Technical Service Information

THM 3T40 (125C) DIFFERENTIAL LOCKING SWITCH

Figure 1

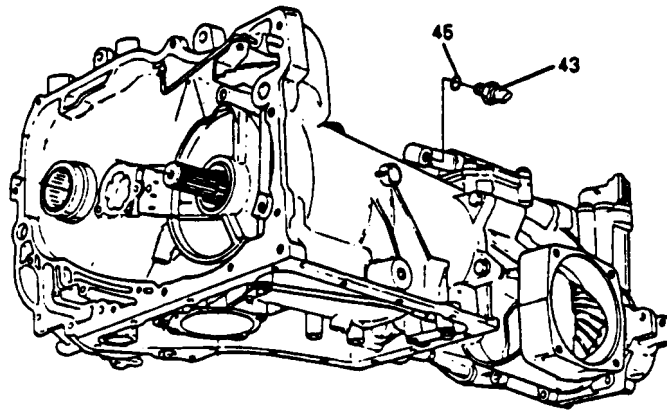
COMPLAINT: 1. AWD LOCK - indicator will remain on, but differential will not lock.
2. ANTI-LOOK - indicator will remain on, and ABS operation would be disabled.

CAUSE: The cause may be an inoperative and/or intermittent Center Differential Locking Switch (See Figure 1) due to moisture entry during the manufacturing process.

CORRECTION: Replace the Center Differential Locking Switch with a new one, now available under OEM part number 8665329.
